UNITED STATES PATENT AND TRADEMARK OFFICE

APPLICATION NO.	FILING DATE	FIRST NAMED INVENTOR	ATTORNEY DOCKET NO.	CONFIRMATION NO.
10/629,366	07/29/2003	Jason P. Eaton	01-18	6288

Office Action Summary	Application No. 10/629,366	Applicant(s) EATON ET AL.	
	Examiner Andrew M. Bunin	Art Unit 3743

Prior Art – US 5771886

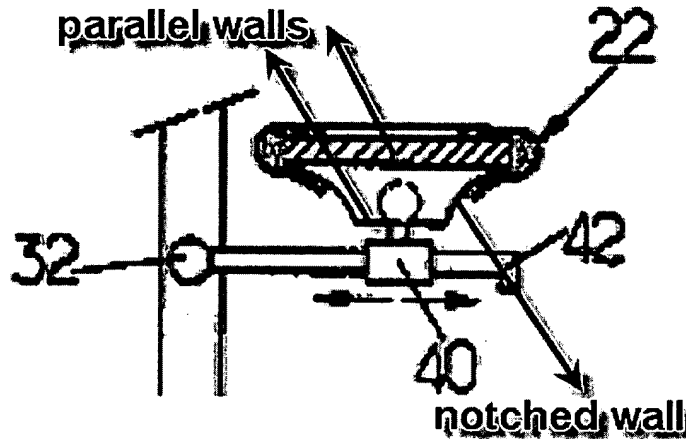
Maire et al. further disclose the first connector 22 is a female connector integrally formed with the shell 24 and the second connector 40 is a corresponding male connector (Figure 3). In addition, the first connector

comprises a pair of parallel walls and a curved notched wall abutting the parallel walls (See Figure below).

Prior Art – US 5771886

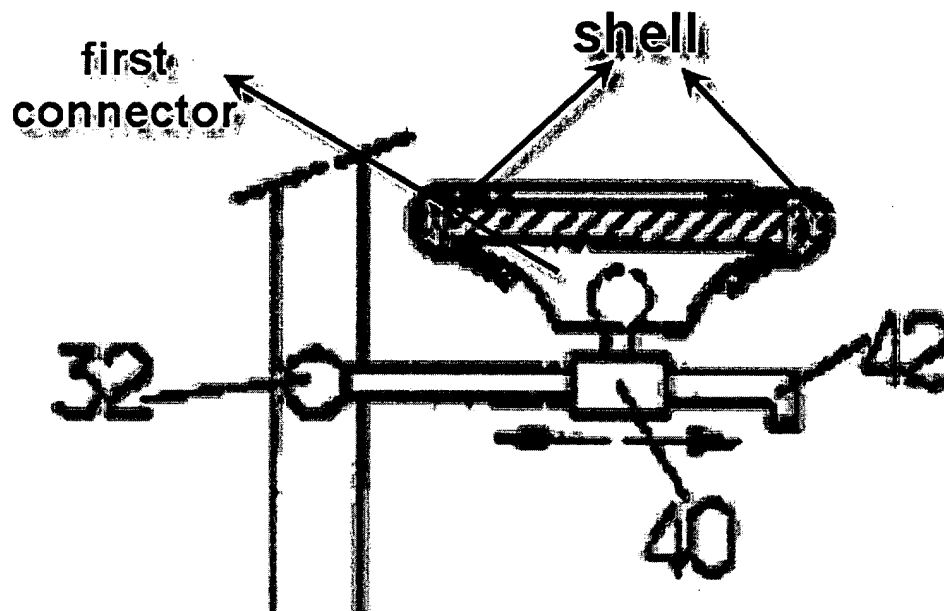
Maire et al. disclose the second connector 40 comprises an elongated portion 28 having an elongated opening (Figures 2 and 3) adapted to receive a headgear strap 20. The second connector 40 comprises a post portion having an axis and extending from the elongated portion 28/42 and a bulbous end portion associated with the distal end of the post portion, the bulbous end portion adapted for insertion in the notched wall of the first connector 22 so as to permit 360 degrees of rotation about the axis of the post portion (See Figures 2 and 3).

Maire et al. further disclose the first connector 22 is recessed with the shell 24 (shaded portion) and the first connector is a male connector integrally formed with the shell (see Figure below).

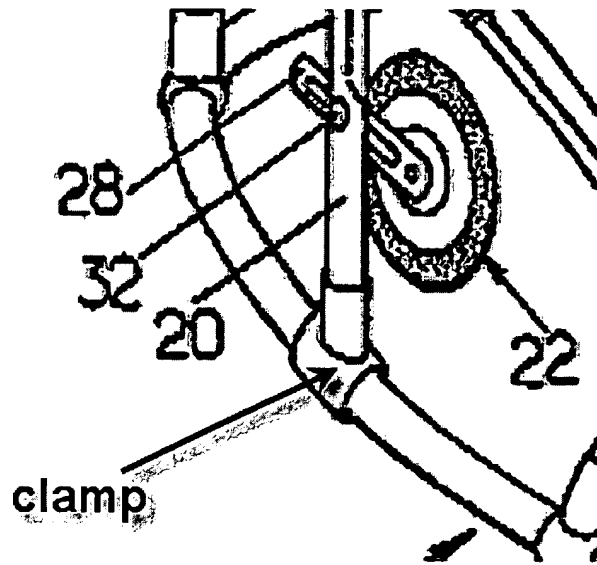
As for claim 11, the second connector 40 has a first portion that releasably connects to first connector 22 and a second portion 28/42 that is adapted to connect to a headgear (straps 16 and 20) having at least one strap for securing the mask on a user (see Figures 1-3). The connecting strap 20 is adapted to connect the headgear to the second connector 40.

As for claim 30, Maire et al. disclose a locking clamp coupled to the connecting strap at the point where 20 meets 16 (see Figure below). The dictionary defines a clamp as a device used to join structural parts (dictionary.com) as shown in the Figure below.
